Sundry Print Reports
07/14/2023

Well Name: CARRACAS 14B Well Location: T32N / R4W / SEC 15 / County or Parish/State: RIO

Notice of Intent

Type of Action: Plug and Abandonment

PROPOSED P&A

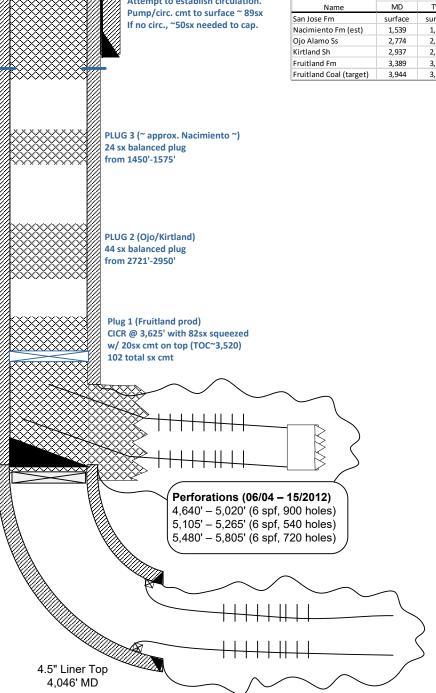
- a. Adjust Plug #1 (Fruitland/perfs) Bring the top of plug up to cover 50' above Fruitland formation top @ 3389' in addition to perfs. Estimated 55 sx cement on top of CICR (3339' 3625').

- b. Ensure bottom of Plug #2 (Kirtland/Ojo) is at least 50' below the Kirtland formation top @ 2937' (Minimum 2724' 2987').
 - c. Adjust Plug #3 (Nacimiento) to cover BLM formation top pick @ 1492' (Minimum 1442' 1542').

- a. Pump squeeze 82sx Class G cement.
 - i. Capacity below CICR and into sidetrack window.
 - b. Spot **55sx** Class G cement on top of CICR.
 - i. If squeeze below doesn't take at least 27sx, skip this step and just pull out of CICR and spot remaining initial squeeze volume on top of CICR.

- ii. Estimated TOC here ~ 3,339' or 286' above CICR.
 - iii. Fruitland formation top at 3389', we need 50' above that to have cmt 3339' per BLM COAs.
- 6. Circulate hole with mud laden fluid.

- 8. Plug 2 (Kirtland and Ojo)
 - a. Pump balanced plug 51sx Class G cement.
 - i. From 2724' 2987'
- 9. Plug 3 (Nacimiento)
 - a. Pump balanced plug 29sx Class G cement.

- i. From 1400' 1550'
- 10. Plug 4 (surface shoe circulation attempt)
 - a. Perforate 255'.
 - b. Attempt to establish circulation...
 - i. if none, spot plug to surface in 7" estimated **50sx** needed.
